LAND CRUISER (70 series)

OUTLINE OF NEW FEATURES

The following changes are made for the new Land Cruiser (70 series).

3. 1FZ-FE Engine

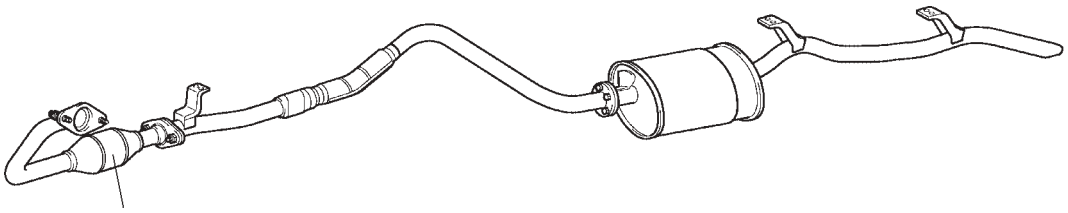
A TWC (Three Way Catalytic Converter) construction change or addition has been implemented for Australia and General countries (FZJ78L-RJMRK and FZJ79L-TJMRK for China and Peru) models to comply with the European STEP-II regulations.
